Quality Control Report

Consultant **Wahib Medanat** Consultant Engineers
Site Name **Jumana Bint Abi Taleb Basic Mixed - Marka**
Package **Package 2**
Contractor **Dijlah Est. Construction Co.**
Tender No. **10/2019/USAID/SKEP/3/2**

Rep No. **QC-23 13**
Date **18 / 12 / 2021**

Defected porcelain floor tiles

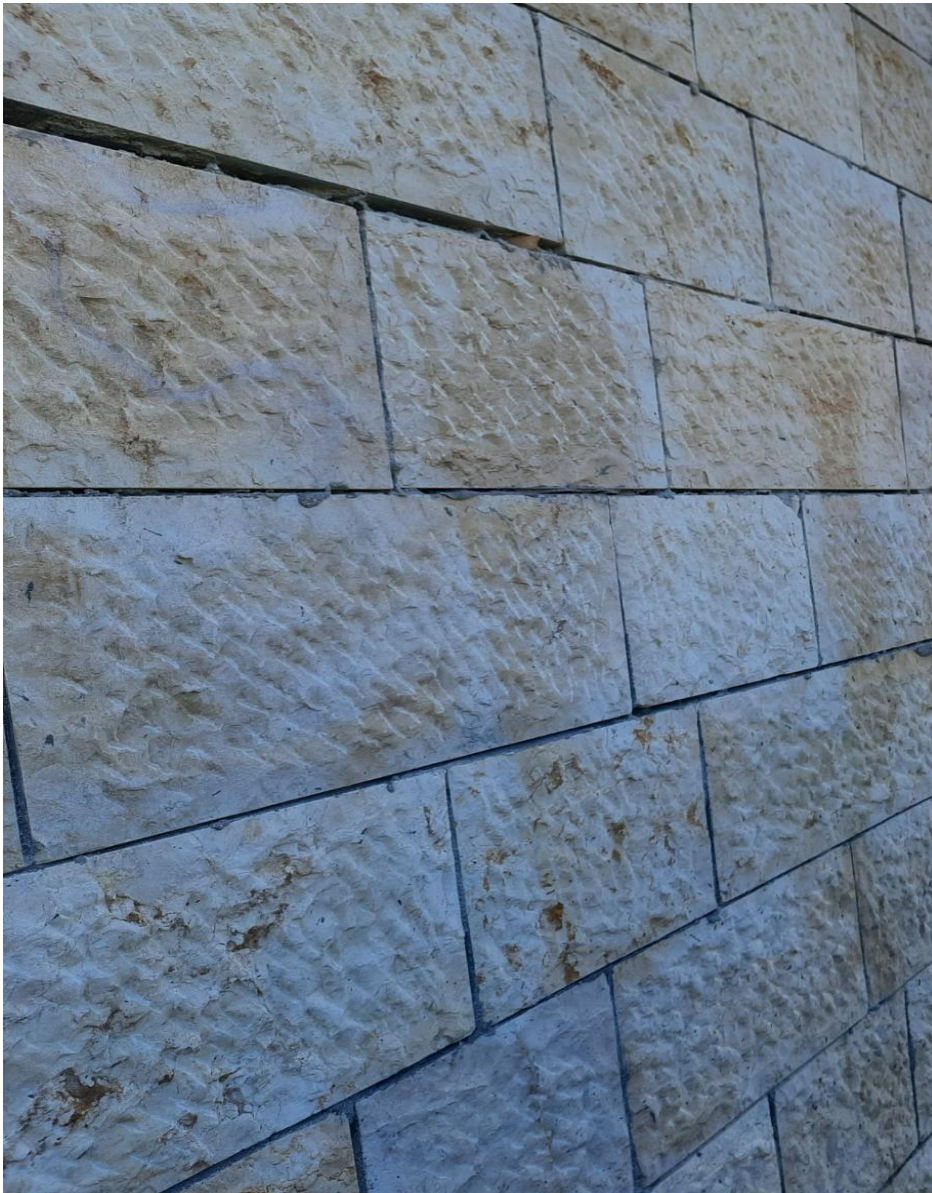
| Description of Non Conformance | Corrective Action | Required by / When |
|---|--|----------------------------|
| <ol style="list-style-type: none"> 1. Defects in coping. 2. Defects in granite of staircases. 3. Defects in floor tiles. 4. Defects in stone cladding. 5. Finishing work for corners is not done properly. | <ol style="list-style-type: none"> 1. Replace defected coping. 2. Replace defected granite tiles. 3. Undergoing/to be checked. 4. Defected stones to be replaced. 5. Rectify to reach sharp corner. | The Contractor/Immediately |

| Description of Non Conformance | Corrective Action | Required by / When |
|---|--|----------------------------|
| <p>It was observed that the Contractor started with the rectification of</p> <ol style="list-style-type: none"> 1. Floor tiles 2. Stone cladding | | |
